Subject: VIRGIL C. SUMMER NUCLEAR STATION UNIT 1
DOCKET NO. 50-395
OPERATING LICENSE NO. NPF-12
TRANSMITTAL OF RADIATION EMERGENCY PLAN REVISION 68

RADIATION EMERGENCY PLAN

EP-100
REVISION 68

Figure 1-1: 10-Mile Emergency Planning Zone (Exposure Pathway)

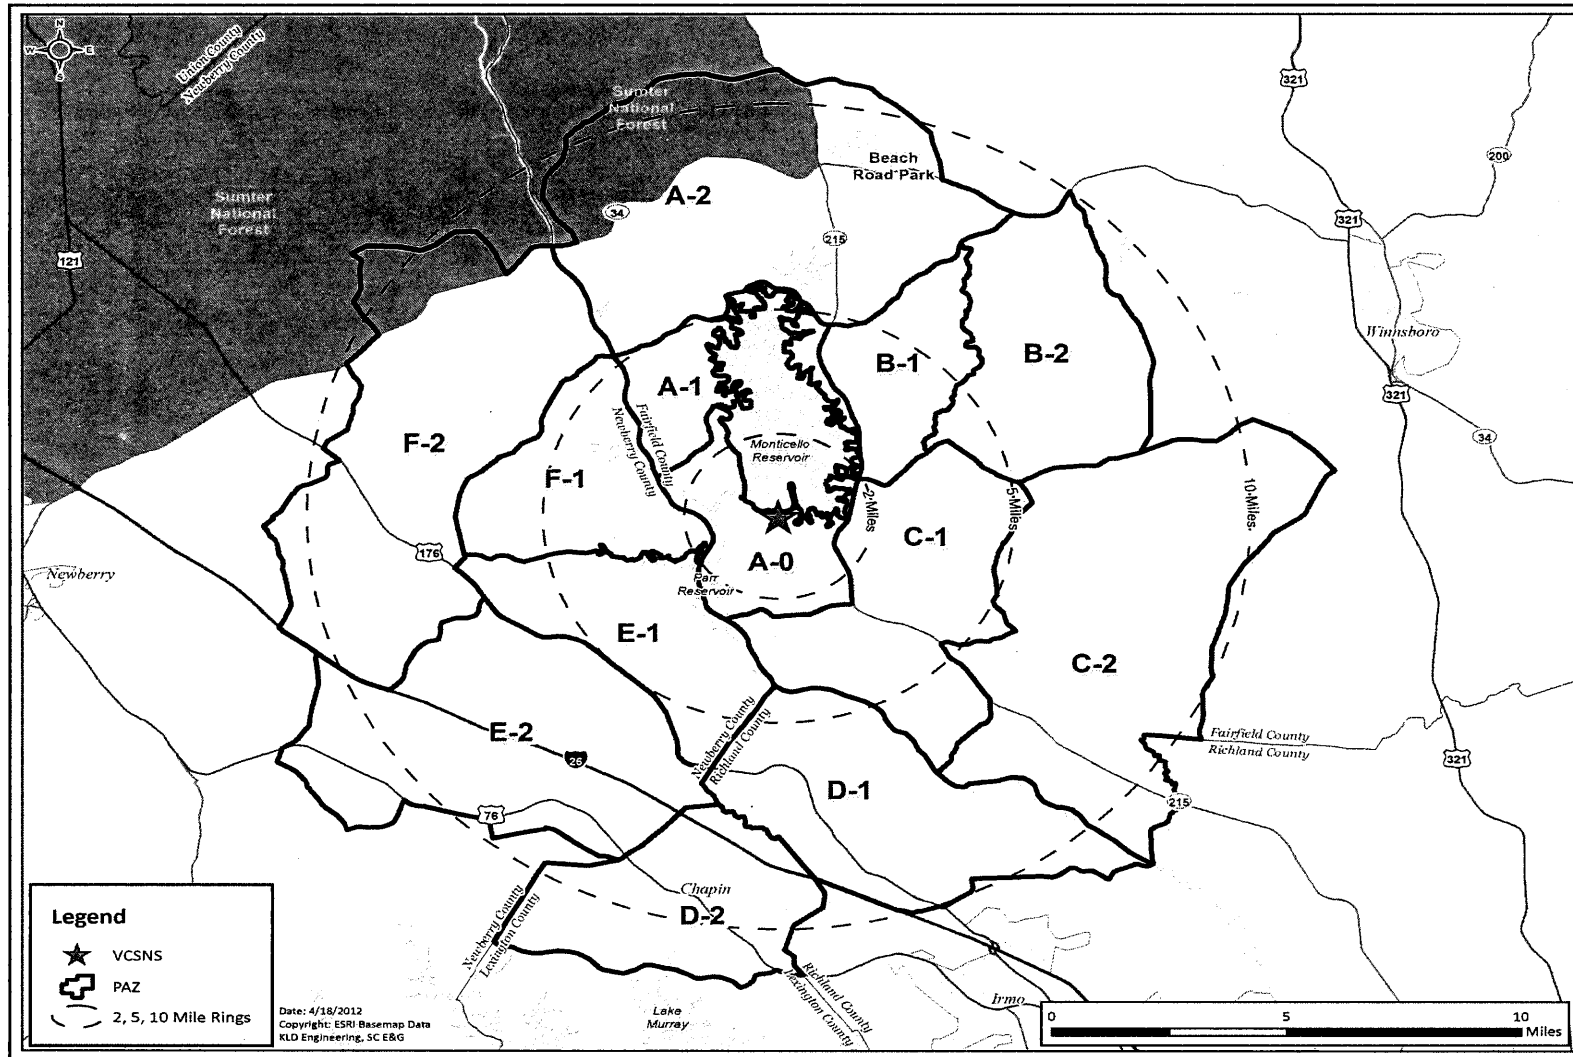
Item	Section	Summary of Proposed Changes	Planning Standard/Function Element(s) Impacted	Justification/Evaluation
7.	Part 1	Deleted Figure 1-1, General Location of the Site and Surrounding Area and renumbered 10-Mile Emergency Planning Zone (Exposure Pathway) to Figure 1-1	NA	<i>Justification:</i> The description of the layout is still in the plan, Part 1 Section B, therefore a map is not needed.
8.	Part 1	Deleted Figure 1-2 V.C. Summer Site Layout and renumbered 50-Mile Emergency Planning Zone (Ingestion Pathway) to Figure 1-2	NA	<i>Justification:</i> The description of the layout is still in the plan, Part 1 Section B, therefore a map is not needed.
9.	Annex 1: Unit 1	Figure A1-1 Unit 1 Facility Layout	NA	<i>Justification:</i> The description of the layout is still in the plan therefore a map is not needed.
